# s72 Amendment Officer Report

PA1600190-3  
1-21 Hornsby Street  
Dandenong

Section 72 Amendment Officer Assessment Report  
Development Approvals & Design

*Endorsed Level 2 floor plan*

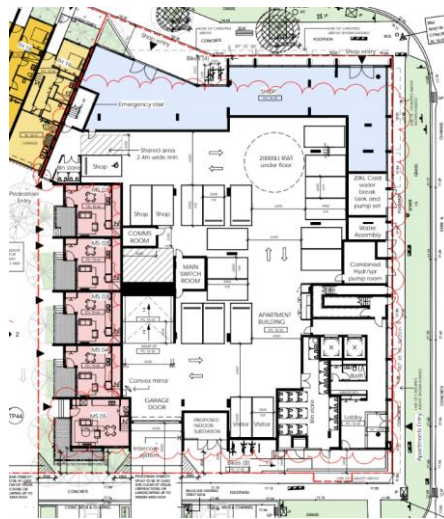
Change / Comment	
<b>Proposed Change</b>	Overall dwelling yield increased by seven apartments from 82 to 89. The proposed increase in overall dwelling yield is achieved through: <ul style="list-style-type: none"><li>• Podium level reduced by one and level two floor plan redesigned to include eight additional apartments.</li></ul>

*Amended ground floor plan*

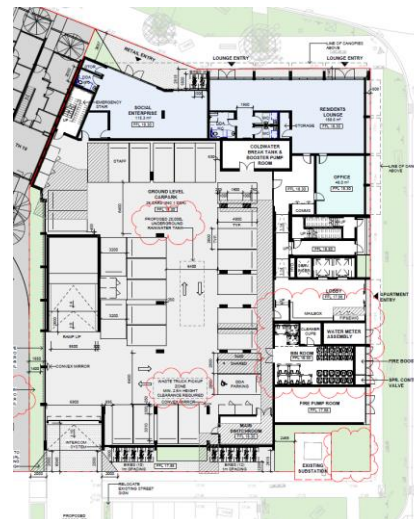
- Maisonettes townhouse dwellings (10 in total) fronting internal western internal road deleted, increasing ground and first floor car parking area and level two communal terrace area.

*Amended ground floor plan (southern setback increased)*

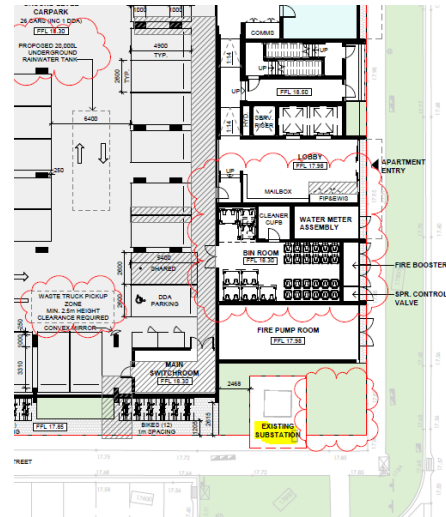
- Increased southern setback to accommodate existing substation at the southeast corner of the site.

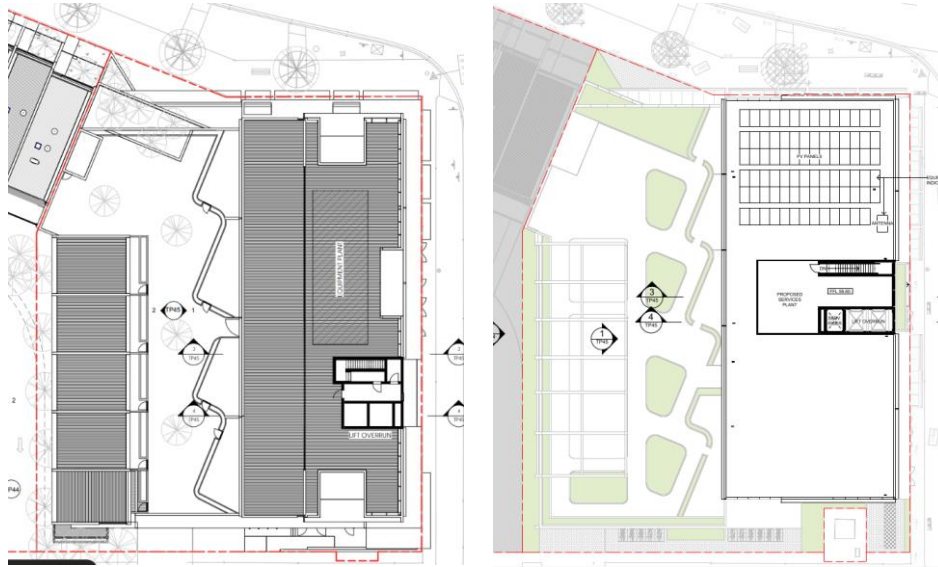
- Various amendments to external and finishes including:
- Extended steel mesh material (MTS3) added to first floor podium car parking level on east, western and southern elevations.
  - Matrix cladding with dark grey paint finish (MX1)
  - Ribbed concrete painted dark grey (PCC6) add to central façade area on the eastern elevation (all floors), in lieu of precast concrete in white and black.
  - Prefinished metal in white (PCA3) added communal garden pergola structure.
  - Prefinished metal in champagne (PCA4) added to upper levels on all facades, in lieu of grey architectural cladding.
  - Metal louvre in black (LVR1) added to upper floor balconies on the eastern and western elevation.
  - Plant trellis wire (TRL1) added to the first-floor podium level on the northern and eastern elevations.

The changes to external materials proposed are generally minor. The amendments maintain an appropriate level of visual interest and articulation on all façades. The proposed materials are a suitable quality and will deliver a positive design response. The changes are recommended for support.
